**Bulletin No.....:** TS-S86

**Bulletin Name.....:** Headlight & Daytime Running  
Lights Control System Correction

**Vehicle Model.....:** TS45

**Summary:** This bulletin is prepared to;

Figure 3

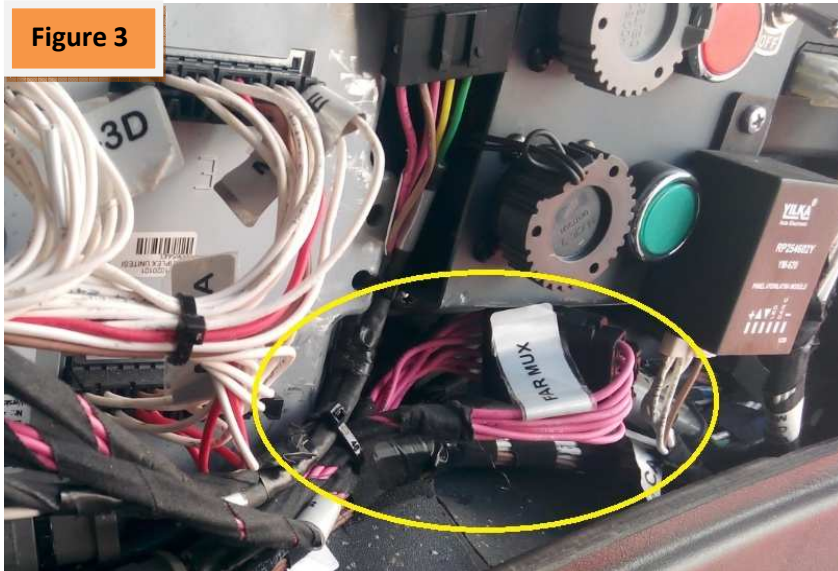
3. Now Headlights must function at that point when you command through headlight switches on dashboard. This is an initial check to see if any faults coming up with the existing harness installed in the vehicle (From Mux unit outputs to headlights)
